# Product Change Notification

**Change Notification #:** 117129 - 01  
**Change Title:** Intel® Server Board BBS2600KPR  
Intel® Server System HNS2600KPR  
Intel® Server Board BBS2600KPFR  
Intel® Server Board BBS2600KPTR  
Intel® Compute Module HNS2600KPFR,  
PCN 117129-01, Product Design, Order Code  
Replacing voltage regulator component,  
**Reason for Revision: Update the TA values for MM# 943790**

**Date of Publication:** August 29, 2019

Figure 1

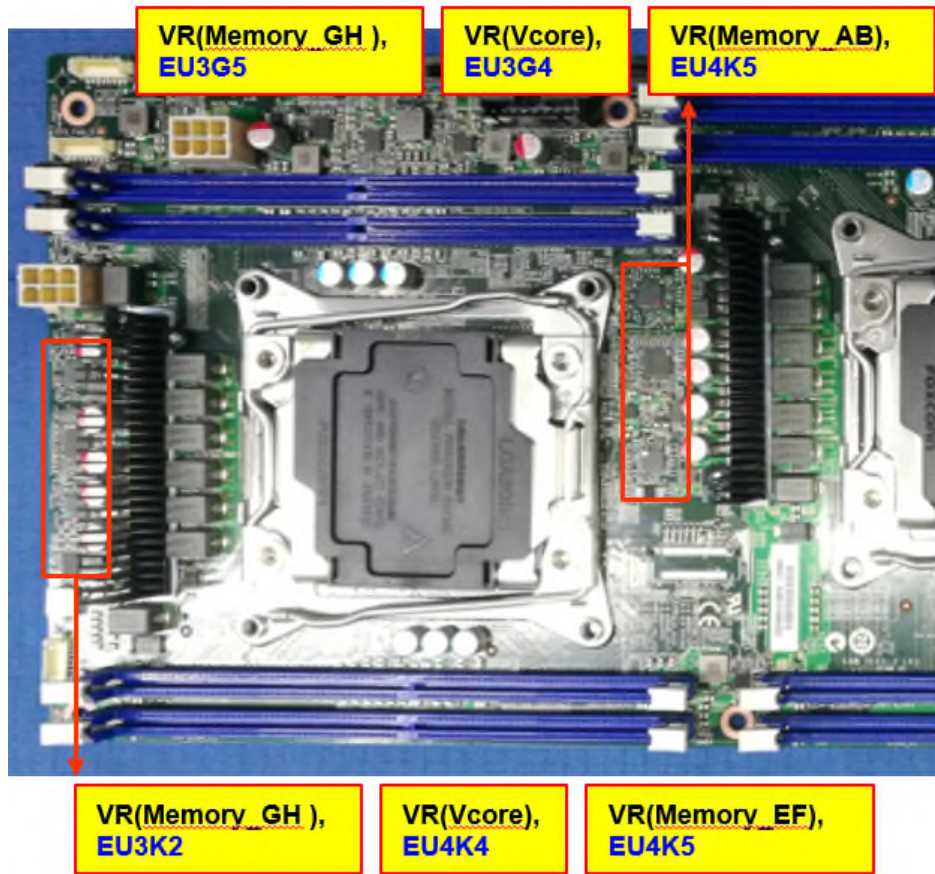
Intel is replacing the TDA21310 Voltage Regulator Microcontroller (VRM) with PXM1310CDM and TDA21460 DIMM VRM on the Intel® Server Board S2600KPR and Intel® Server System HNS2600KPR due to the End of Life of the previous components. The new component is identical in form, fit and functions of the previous ones. Intel reports validation completed with passing results. Location of the replaced components is shown in Figure 1.
